IIoT Product End-of-Life Notice

End of Life, Last Time Buy and Replacement Announcement

For immediately release, Advantech is announcing the End of Life (EOL) of **ADAM-4053-E**. The relative replacing models are as below list. Customers who had purchased this Part Number either to purchase any additional rules or migrate to the new replacement models if possible before the EOL's shipment date.

Product Part Numbers Affected by This Announcement

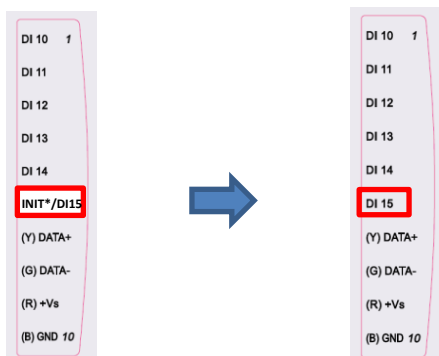
Replace the key component TI MCU 1400006109-01(MSP432P401MIRGCR) with new MCU, because MSP432P401MIRGCR L/T is longer than 371 days.

Impact	New version
Pin assignment	INIT*/DI15 changes to DI15
Hardware spec	Backward compatible
FW	New version A 4.01 or later
Utility	Adam/Apax .NET Utility 2.6.00 B15 later version

- INIT*/DI15 changes to DI15

1. Enable data format settings (parity none/odd/even, stop bit 1/2) for ADAM ASCII protocol
2. Add Initial switch

End of Life Product	Suggest Replacement Product	Sample Available Date
ADAM-4053-E	ADAM-4053-F	Available in 2022/06/20
